Security considerations for Management Proxies 60802 Draft 3.0

October 2024

Jordon Woods, Self-affiliated

Alternative proposal

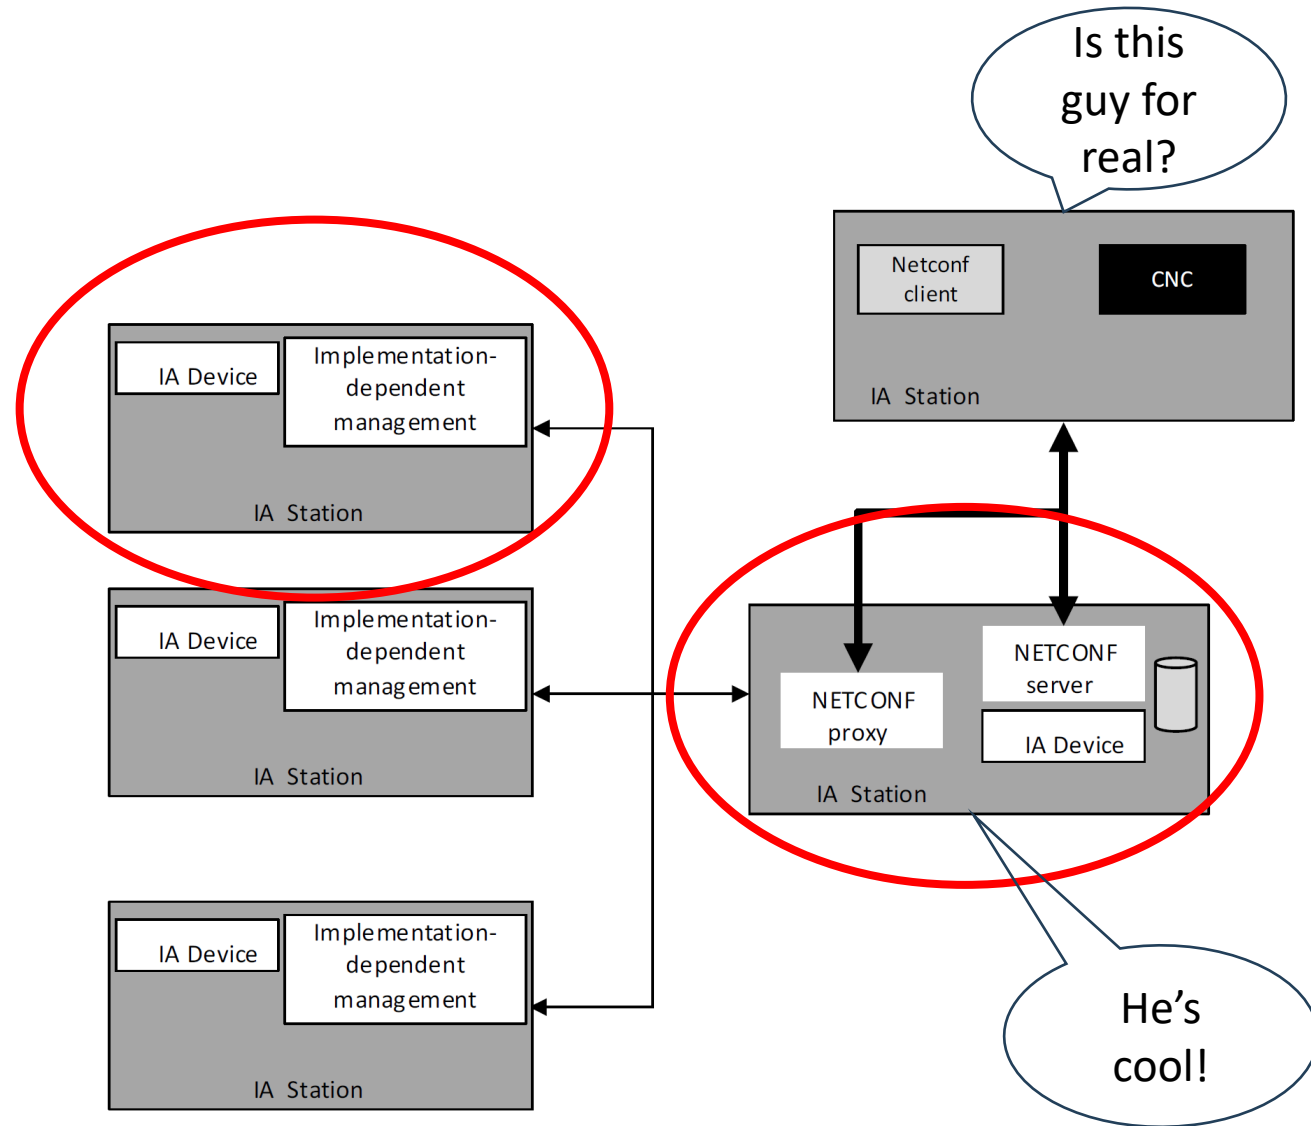
- The CNC detects via LLDP that the proxied device is using a different management address.
- If and only if, that management proxy exists in the network, the CNC issues an RPC to the proxy
- The proxy performs the following steps:
 - Joins the isolation VLAN.
 - Authenticates the new device via a user-specific means. Ensuring the security of this user-specific mechanism is the responsibility of the user.
 - Returns the result of the Authentication to the CNC.
 - Leaves the isolation VID.
- Based upon the results of the authentication, the CNC sets the boundary port state appropriately.
